ITEM # 3.0

**PRELIMINARY & FINAL
PLAT APPROVAL:**

Retama Phase VI Subdivision
Being 9.173 acres out of Lot 14
Del Monte Irrigation Co. Subdivision
PUD (R-1)
Developer: Rhodes Development, Inc.
Engineer: Melden & Hunt, Inc.

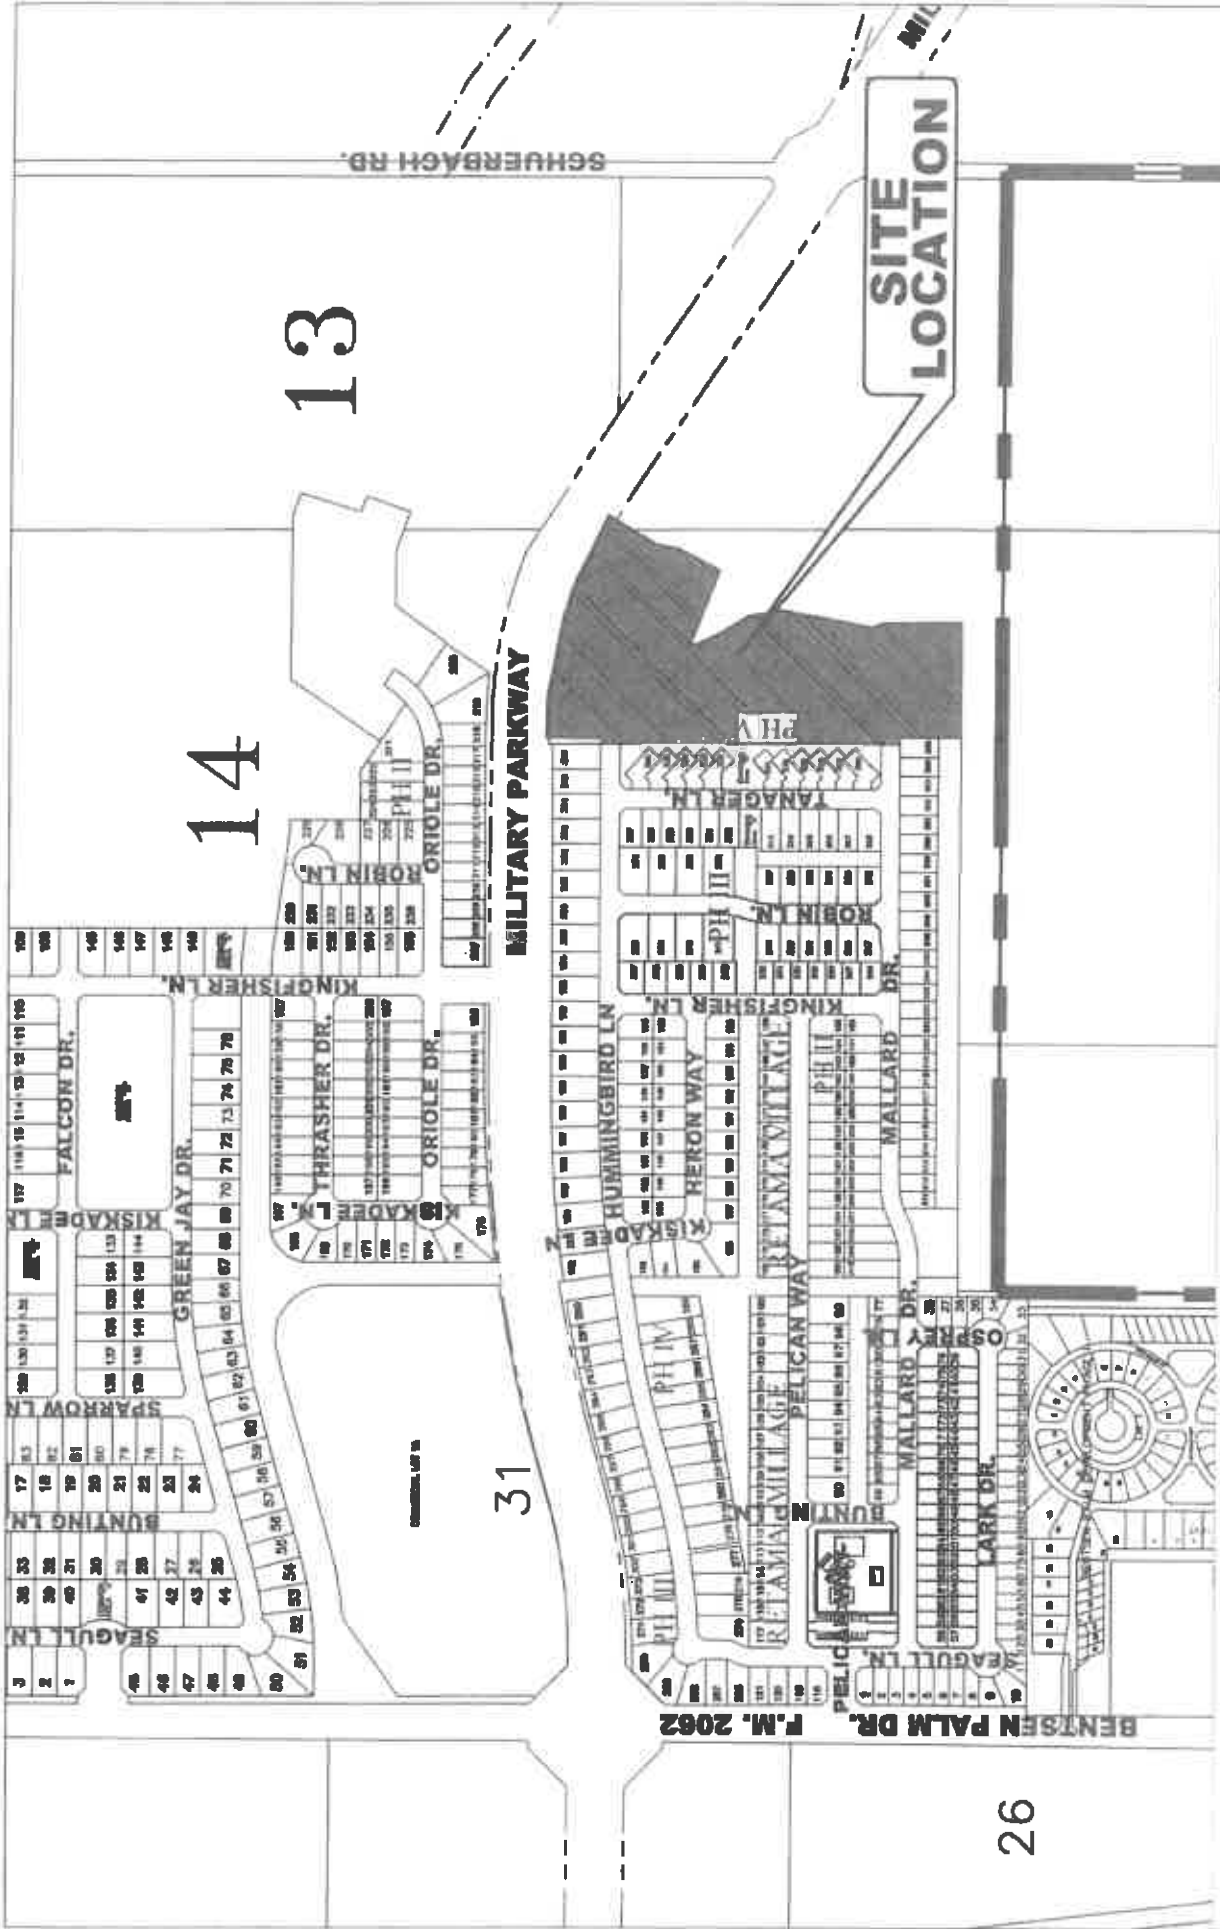
Request variance from Sec. 98-134 'Streets' of the Code of Ordinances Ch. 98 - Subdivisions to allow the design and proposed construction of a 30' ROW whereas the code requires streets within a subdivision to be at least 50'.

Request variance from Sec. 98-134 'Streets' of the Code of Ordinances Ch. 98 - Subdivisions to allow a pavement width of 30' whereas the minimum pavement width of minor residential streets shall have 32' back-to-back

The subdivision will have 2 existing streets extended from phase V (Hummingbird L. and Ballard Dr.) to have dead-ends for future expansions with a main access to Military Pkwy East from Hummingbird Ln. between Lots 340 & 341. This access will have an 80' ROW with median islands. The design will also include an internal street with a proposed paved 30' ROW.

Staff recommends denial to include all variances due to the lack of evidence for any hardships or willingness to fulfill required subdivision design criteria.
